**STAFF REPORT: 7/12/2023 MEETING**

**APPLICATION NUMBER: #23-8434**

**ADDRESS: 1120 SEMINOLE**

**SCOPE: ERECT GREENHOUSE (WORK COMPLETED WITHOUT APPROVAL)**

Figure 1 by Applicant (altered by staff for clarification), showing location of hoophouse in red.

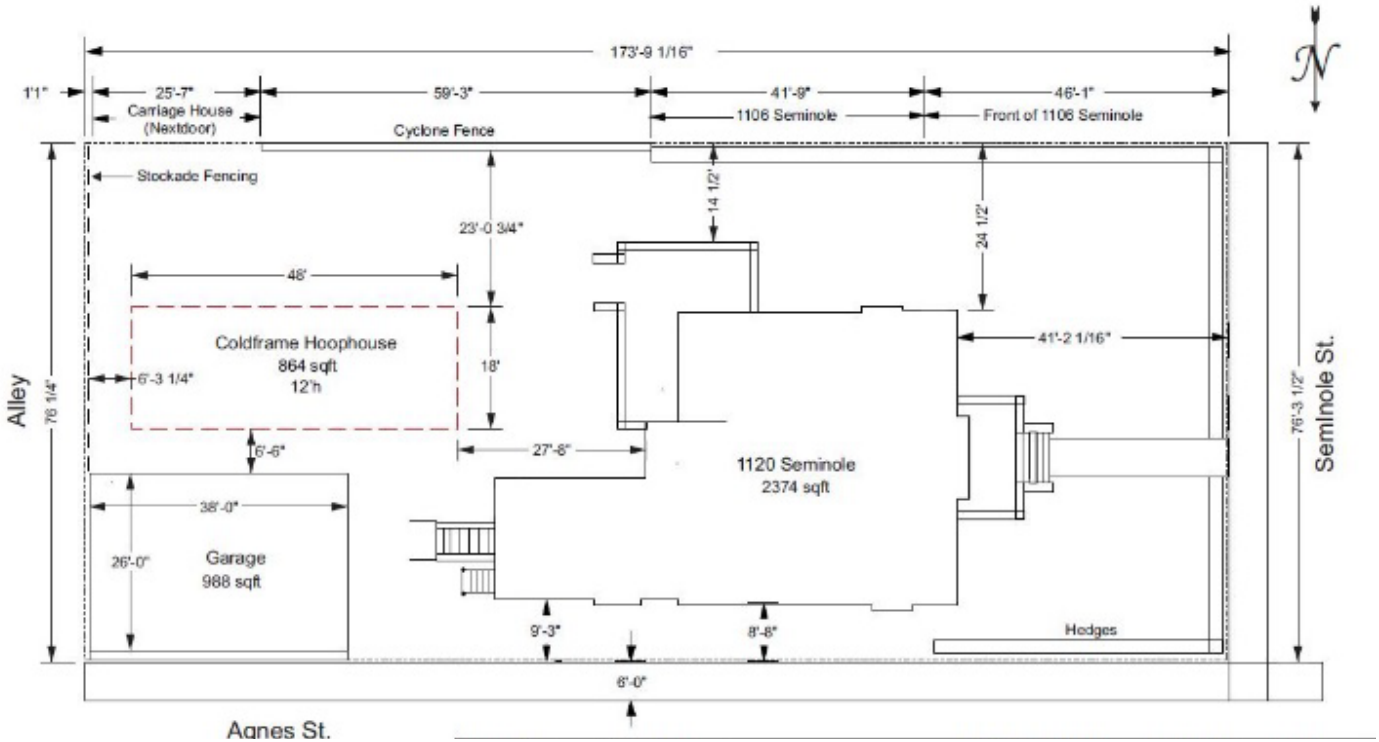
- The 13,148SF lot currently contains a 2374SF house and a 988SF garage, which is approximately 26% of the Relationship of Lot Coverage, which falls within the 20-30% range as described in the Elements of Design. The addition of a this hoop house (864SF) would increase the lot coverage by these structures to 32%, which is slightly outside of this range. The scale of this hoop house exceeds the appropriate size for this lot and does not meet the *Relationship of lot coverage* as described in the Elements of Design.

- Staff has the opinion that the 12’ height, gothic-style roof form and plastic materials are not appropriate as permanent materials as they conflict with the *Relationship of roof shapes* and *Relationship of materials* Elements of Design as listed above.

- Because of the structure’s height and massing, it is publicly visible from the front yard, as well as the side walkway and the rear, despite the surrounding privacy fence.

- Because the parcel is located at the intersection of Seminole and Agnes streets, the structure is highly visible from the public right-of-way.
- The proposed hoop house is a clearly mass-produced, machine-made product that is visually incongruous with the Colonial Revival architecture described above and is not appropriate as a permanent structure. A limited time use may be an appropriate option for this particular property.
- The scale of the hoop house is not deferential to the scale of the house and is not a modern interpretation of the character of Colonial Revival homes. Design elements such as the 12’ high gothic arch roof and materials such plastic and metal tubing are not appropriate to the Colonial Revival character of the property.

It is staff’s opinion that the application as proposed does not meet the Standards due to the scale and materiality of the structure and the applicant’s desire to retain the hoop house indefinitely. However, in staff’s opinion, the hoop house would meet the Standards if it was maintained on a temporary basis because the essential form and integrity of the historic property and its environment would be unimpaired when it is removed due to the nature of structure. Staff therefore recommends that the Commission issue a Certificate of Appropriateness for the hoop house with the following conditions:

1. The applicant shall afford the Commission the opportunity to define an appropriate timeframe which the hoop house may remain as a temporary structure within the subject parcel.
2. The applicant shall remove the hoop house and restore the property to an appropriate condition, per staff review, upon the expiration of the Commission’s defined temporary period.
